**REFERENCE:** Docket 50-407  
The University of Utah – TRIGA Research Reactor (UUTR)  
License No. R-126

**SUBJECT 2): Copy of proposed TS: final form of Chapter 6.0 titled ADMINISTRATIVE CONTROLS**

Note: changes from the TS submitted in 2005 are in **CHAPTER 6** [Fig.6.1 is clarified; whole Chapter is rearranged to follow the ANSI/ANS 15.1-2007 and NUREG 1537 Part 1 & 2]

**Figure 6.1**  
**University of Utah Administrative Organization for Nuclear Reactor**  
**Operations [Clarified - December 2009; in compliance with ANSI/ANS**  
**15.1-2007]**

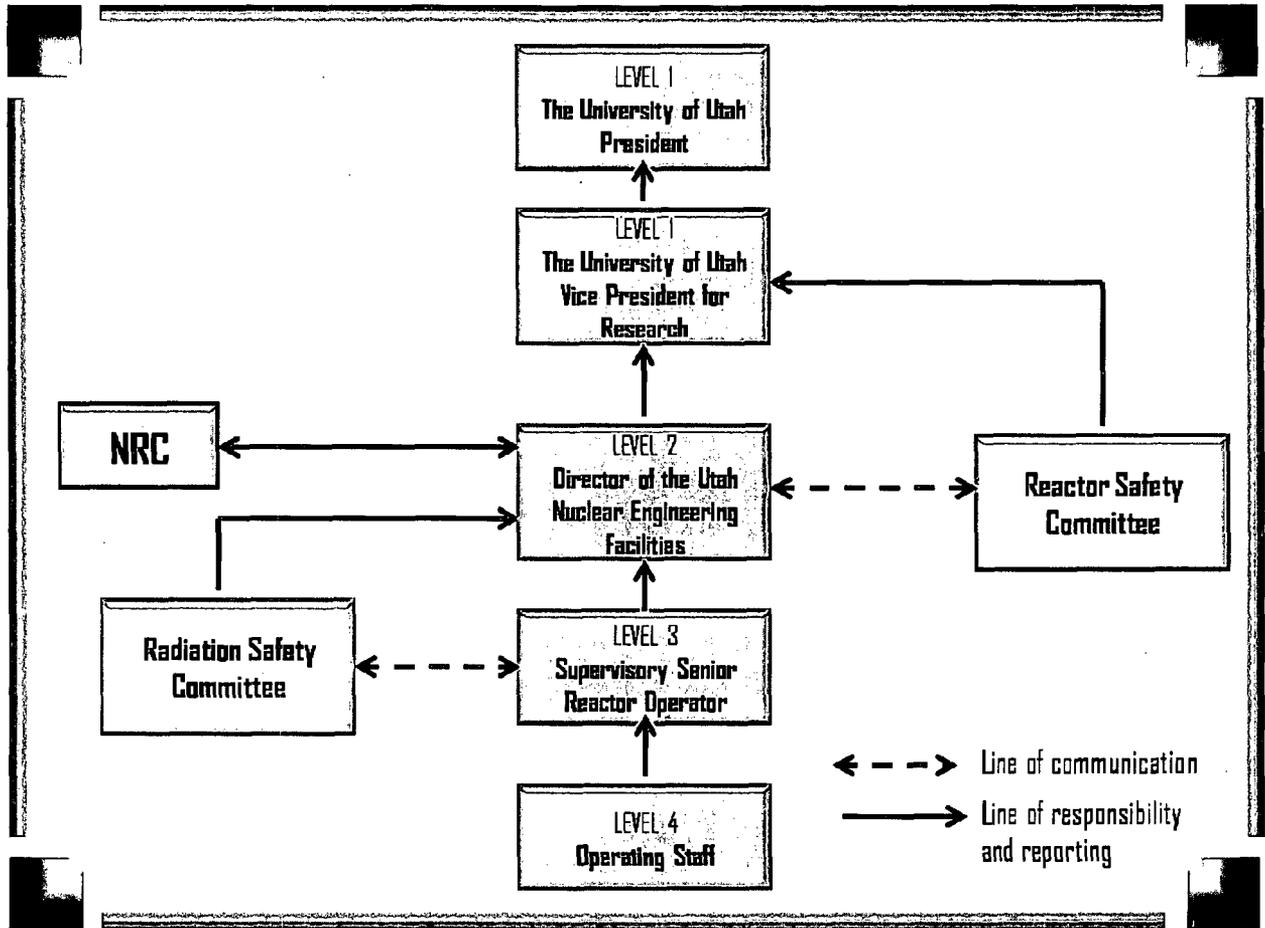
- 1) The UUTR is an integral part of the Nuclear Engineering Facilities of the University of Utah. The organization of the facility management and operation shall be as shown in Figure 6.1. The responsibilities and authority of each member of the operating staff shall be defined in writing.
- 2) As indicated in Fig. 6.1, the Reactor Safety Committee shall report to Level 1. Radiation safety personnel shall report to Level 2. Additional description of levels follows:

*Level 1:* Individual responsible for the reactor facility's licenses, i.e., the Associate Vice President for Research in the Office of Vice President for Research; The Vice President for Research will assign which of the Associate Vice Presidents for Research will be the responsible Level 1 individual.

- b. *Level 2:* Individual responsible for reactor facility operation, i.e., the facility director shall be the Director of the Utah Nuclear Engineering Program, who shall also be the Director of the Nuclear Engineering Facilities of the University of Utah;

*Level 3:* Individual responsible for day-to-day operation or shift shall be the reactor supervisor (RS). This person shall be a senior reactor operator (SRO).

- d. *Level 4:* Operating staff shall be senior reactor operators, reactor operators, and trainees.

- a. In the absence of the Level 2 individual [sabbatical leave, sudden leave]: Level 1 shall have the authority to automatically appoint the RS as an interim reactor administrator (RA) with direct access to Level 1 and communication to U.S.N.R.C; Radiation safety personnel shall report to RA unless Level 1 decides differently;
- b. In the absence of the Level 3 individual [sabbatical leave, sudden leave]: Level 2 shall have the authority to automatically appoint a new RS who shall be a most senior Level 4 individual (SRO).
